FORA ESCA REMEDIATION PROGRAM

FINAL Group 1 Remedial Investigation / Feasibility Study Work Plan

Volume 2 - Sampling and Analysis Plan

Parker Flats Munitions Response Area Phase II

Figure F-2

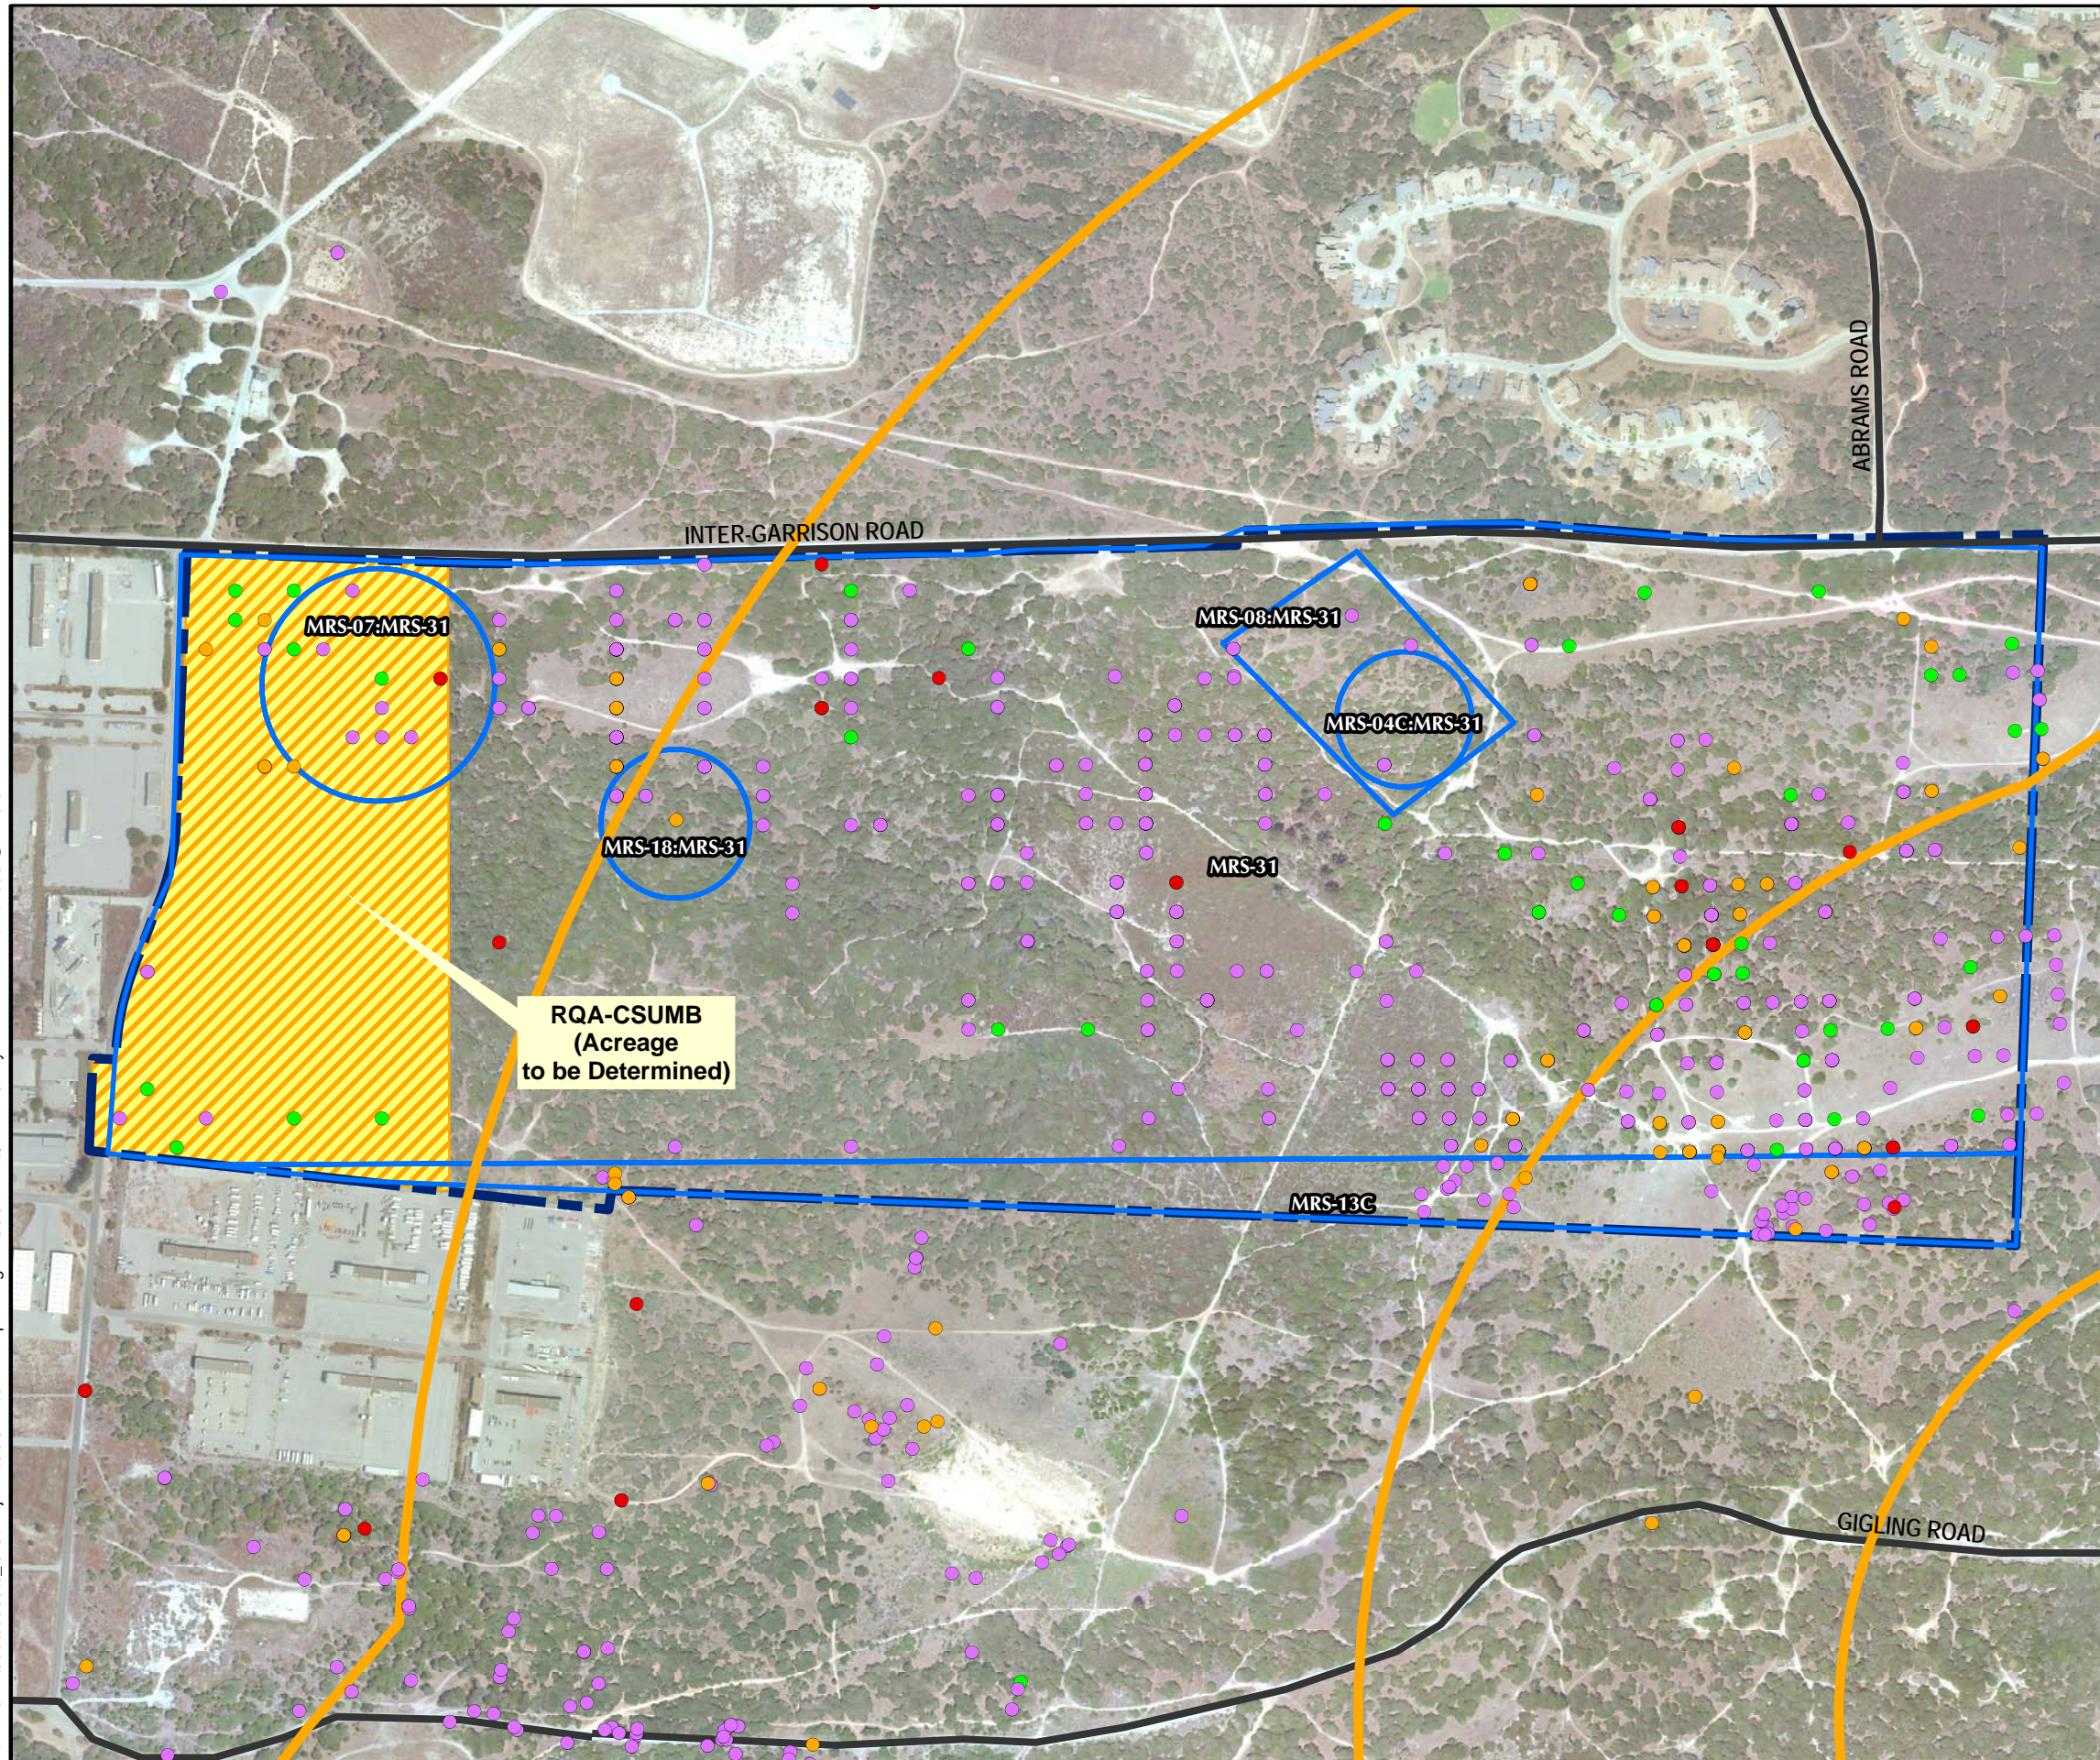
28. Appendix F: Residential Quality Assurance Pilot Study Work Plan. Figure F-2. The legend describes hazard classification 0 as "Inert MEC that will cause no injury." By definition MEC is explosive in nature, therefore "inert" classification is not possible for a MEC item. Classification 0 should be described as "inert munitions item that will cause no injury" instead.

No.	Comment Type / Report Section	Comment/Response
	Assurance Pilot Study Work Plan. Figure F-2	Response: The figure has been revised to read “ <i>inert munitions item that will cause no injury.</i> ”
29	Army Specific Comment, Appendix I: Explosives Siting Plan. Section 1.6.1	Comment: Detonation Site Blow-In Place. The second to the last bullet discusses that after property transfer, fire risk assessment for planned detonations will be conducted by the City of Seaside Fire Department. Please verify if this is the case since the majority of the investigation area is within the jurisdiction of the Monterey County. Response: The second to the last bullet in Section 1.6.1 of Appendix I has been revised as follows: <ul style="list-style-type: none"> • “Request Presidio of Monterey Fire Department (POM FD) to perform an on-site fire risk assessment. For planned detonations, risk assessments require a 3-day notification and demolition shots require a 5-day notification. POM FD will expedite risk assessments for demolition shots that cannot be delayed. Following property transfer, requirements for risk assessments will be determined by the City of Seaside Fire Department, <i>if the detonation is being conducted within the jurisdiction of the City of Seaside, or by the Salinas Rural Fire District, if the detonation is being conducted within the jurisdiction of Monterey County.</i>”
